# Access Compliance Report

## Public Rights-of-Way

### (Curb Ramps)

Intersection ID: 19938	Main Street: ARCHDALE_DR	Cross Street: MONTCREST_DR	Location: SE
ADA ID: F884C5E08CE3	Ramp Type: PerpDiag	Initial Pass/Fail: Fail	Overall Compliance: No
Severity Score: 12.5			
Codes/Mitigation Info/Possible Solution		Field Measurements/Component Compliance

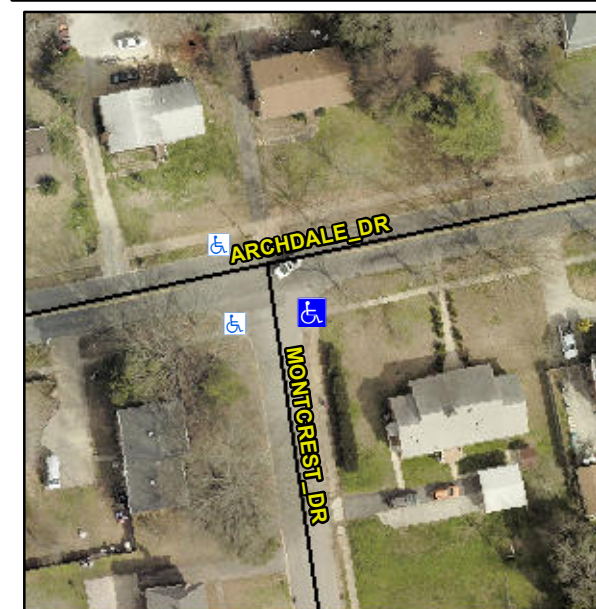
**Not Found, R304.5.3**

Compliance	Description	Data	Compliance	Description	Data
N/A	Ramp Length (in)	83.0	Yes	Ramp Slope (%)	5.6
Yes	Ramp Width (in)	48.0	No	Ramp XSlope (%)	5.6
N/A	Flare Type LT	N/A	N/A	Flare Type RT	N/A
N/A	Flare Slope LT (%)	N/A	N/A	Flare Slope RT (%)	N/A
N/A	Flare Traversable LT?	N/A	N/A	Flare Traversable RT?	N/A
N/A	Landing Length (in)	N/A	N/A	DWS Provided?	N/A
N/A	Landing Width (in)	N/A	N/A	DWS Contrast?	N/A
N/A	Landing Slope (%)	N/A	N/A	DWS Length (in)	N/A
N/A	Landing X Slope (%)	N/A	N/A	DWS Full Width?	N/A
N/A	Landing Curb? (Y/N)	N/A	N/A	DWS Offset (in)	N/A
N/A	Shared Landing?	N/A			
N/A	Gutter Ponding?	N/A	N/A	Gutter Slope (%)	N/A
N/A	Gutter Lip Ht (in)	N/A	N/A	Gutter X Slope (%)	N/A
N/A	Painted X Walk1?	No	N/A	Painted X Walk2?	No
	X Walk 1 Direction	To N		X Walk 2 Direction	To W
N/A	X Walk 1 Width (in)	N/A	N/A	X Walk 2 Width (in)	N/A
	X Walk 1 Slope (%)	1.3		X Walk 2 Slope (%)	0.4
	X Walk 1 X Slope (%)	1.6		X Walk 2 X Slope (%)	0.2

**Remove & Replace Curb Ramp With Two New Directional Ramps or Equivalent.**
